Correction of Peer Delay Measurement for Frequency Offset of Responder Relative to Requestor Revision 2

IEEE 802.1 AVB TG
2008.09.15

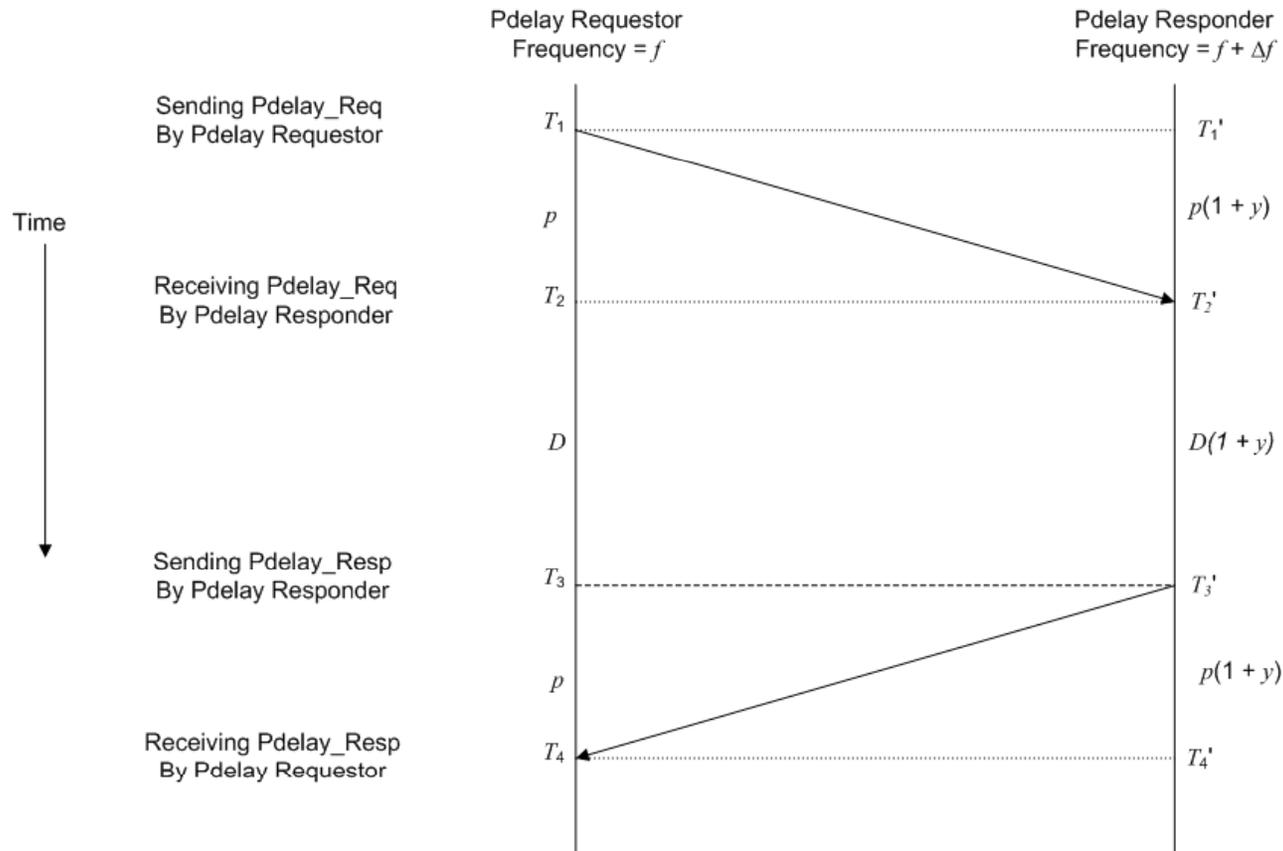
- ❑ Comment #24 of the initial 802.1AS D4.0 comments indicates that the multiplication by neighborRateRatio r should be a division in Eq. (11-2), given that r is defined as the ratio of the rate of the responder to that of the requester.
- ❑ Eq. (11-2) in D4.0 is:

- ❑ According to comment #24, this equation should read

$$\text{mean-propagation-delay} = \frac{(t_4 - t_1) - (t_3 - t_2) / r}{2}$$

- ❑ The purpose of this presentation is to derive the correct form for this equation
 - The form given in the proposed resolution of comment #24 (i.e., with the division by r) is a very good approximation
 - The presentation derives an alternative good approximation, and also an exact for
- ❑ **Note: the only difference between Revisions 1 and 2 is the correction of typos**
